UNITED STATES
NUCLEAR REGULATORY COMMISSION

SUBJECT: PHOTOGRAPHS FROM SEPTEMBER 20, 1989 SITE VISIT
TO THE L-BAR MILL

On September 20, 1989, the authors visited the L-Bar Mill site to conduct a review of construction records and to observe the completed reclamation construction activities. Results of the inspection are contained in inspection report No. 40-8904/89-003 dated October 16, 1989.

Photo 10 - Large Riprap in Swale

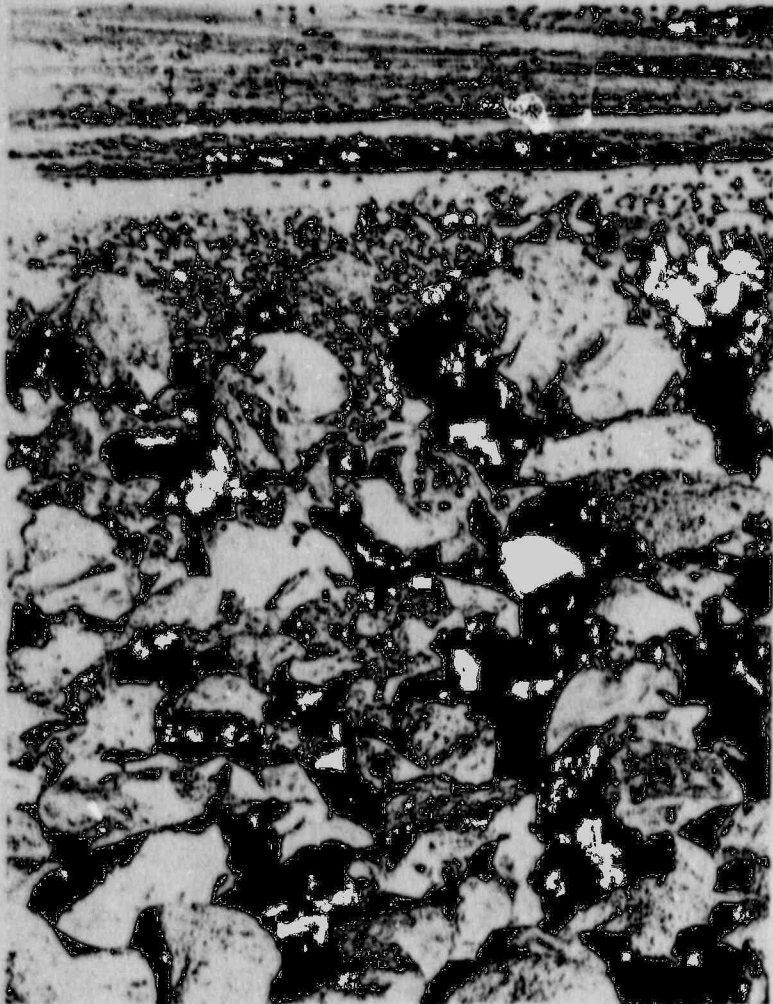
Note pockets of small bedding and bare spots.
